UNITED STATES DEPARTMENT OF COMMERCE
Patent and Trademark Office

09/476,521 01/03/00 GROPP

Office Action Summary

Applicant(s)
GROPP et al.

Fig. 1

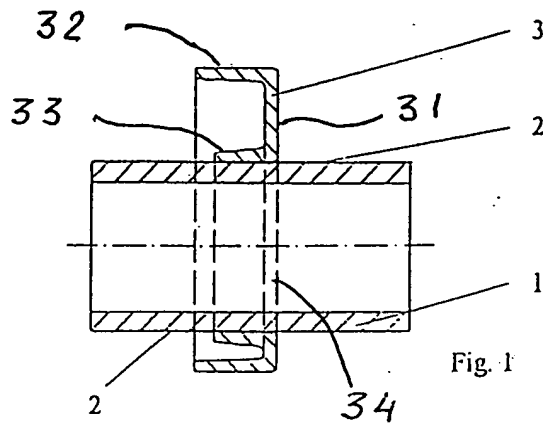
(C) The corrected Fig. 1 has been approved.

10. The original drawings are objected to because: (a) the drawings should show the plane upon which a sectional view such as Fig. 1 is taken; and (b) each part of the invention such as the solid rod in claim 15 should be designated by a referential numeral or character. Correction is required.

Fig. 2

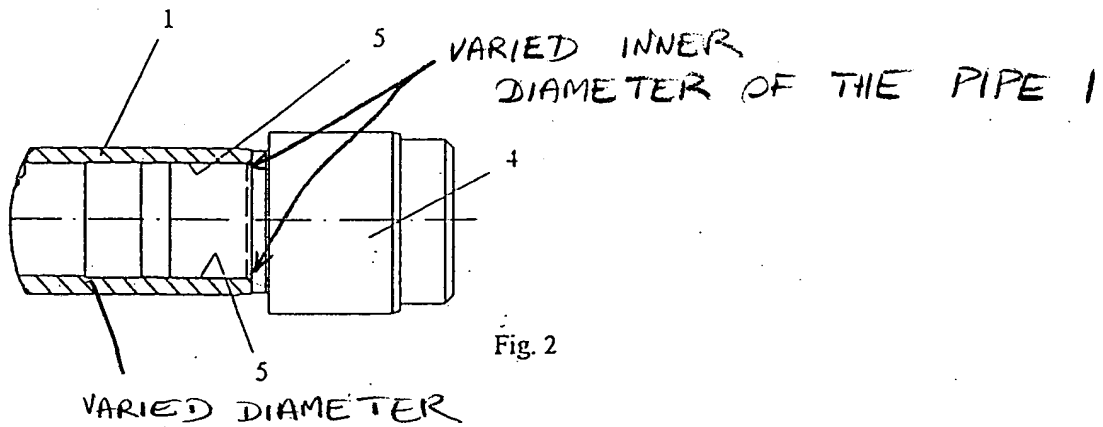
(a) new Fig. 4 introduces new matter such as the end piece 4 as now shown. The original Fig. 2 shows that the inner diameter of the pipe 1 is varied: (1) at the junction of the end piece 4 and the pipe 1 as shown by applicant's phantom line; and (2) at referential numeral 1 (see attached Exhibit). However, Fig. 4 shows that the inner diameter of the pipe 1 is constant. The original disclosure does not convey the concept that the inner diameter of the pipe 1 is constant, thus, it is unsupported by the record as filed. *In re Anderson*, 176 U.S.P.Q. 331 (CCPA 1973); and

Not
Approved
VL
10/20/00

Fig. 3

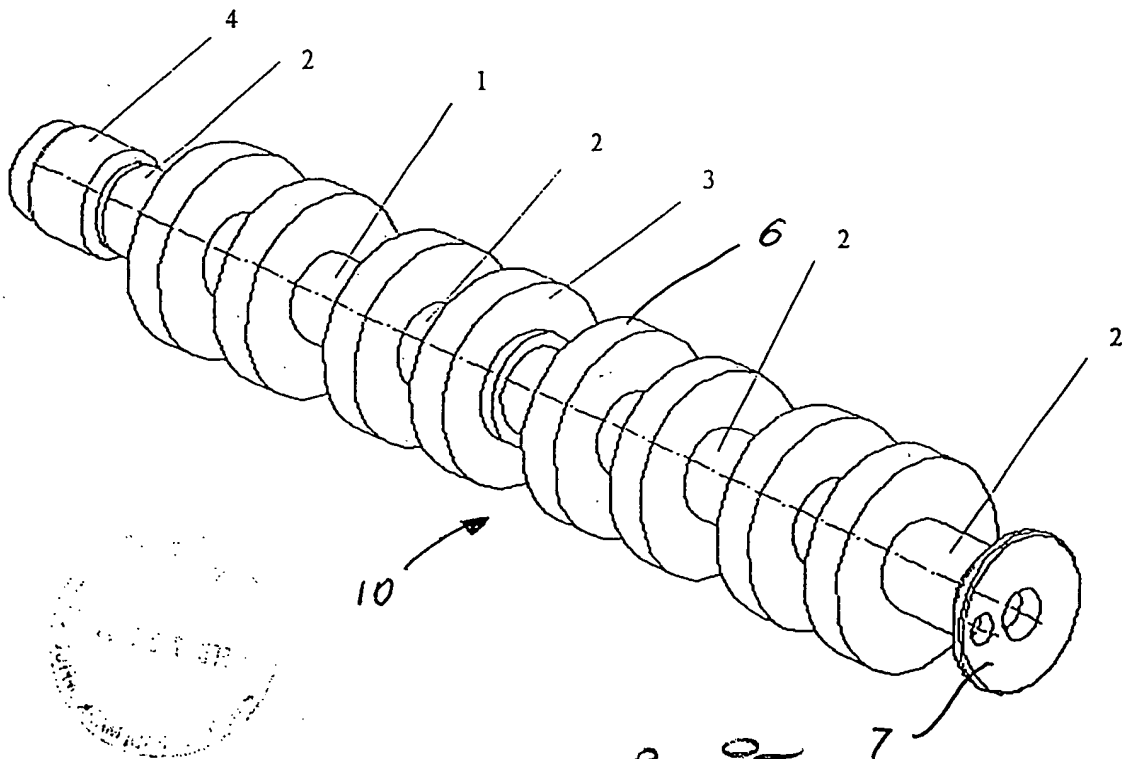
(B) The corrected Fig. 3 has been disapproved since it introduces new matter. The original drawings do not show the bearing rings. The corrected Fig. 3 now shows the bearing 6 which is identical to the cam 3. The showing and description of a specific type of bearing within a full spectrum of possible bearings is considered under the present disclosure to be new matter. *Cf.*, *In re Smith*, 173 U.S.P.Q. 679 (CCPA 1972) and *Ex parte George*, 230 U.S.P.Q. 575, 578 (Bd. Pat. App. & Inter. 1986).

Disapproved
VL
10/20/00

Fig. 4

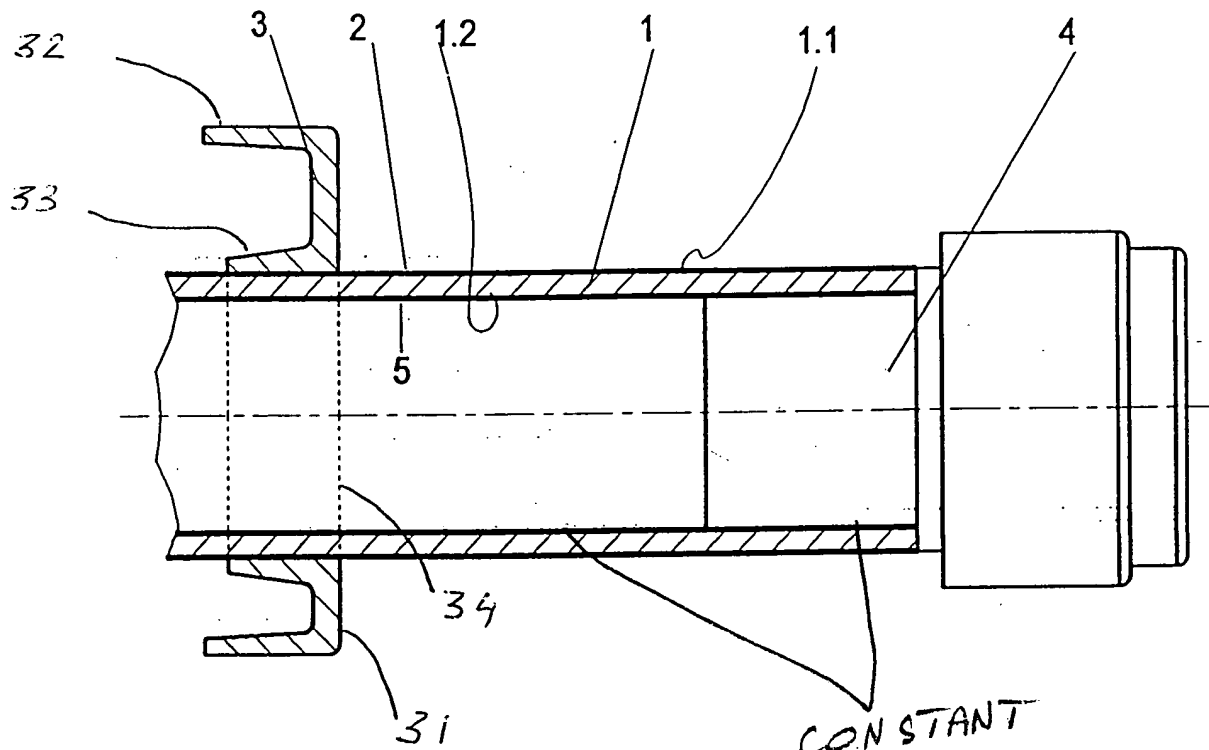
(b) new Fig. 4 is inconsistent with the description in Paper No. 9. The insertion on page 6, line 12 of the specification, states that the outer diameter of the end piece 4 is slightly larger than an inner diameter of the pipe 1. However, Fig. 4 shows that the outer diameter of the end piece 4 is equal to the inner diameter of the pipe 1.

CONSTANT
DIAMETER
(NEW MATTER)
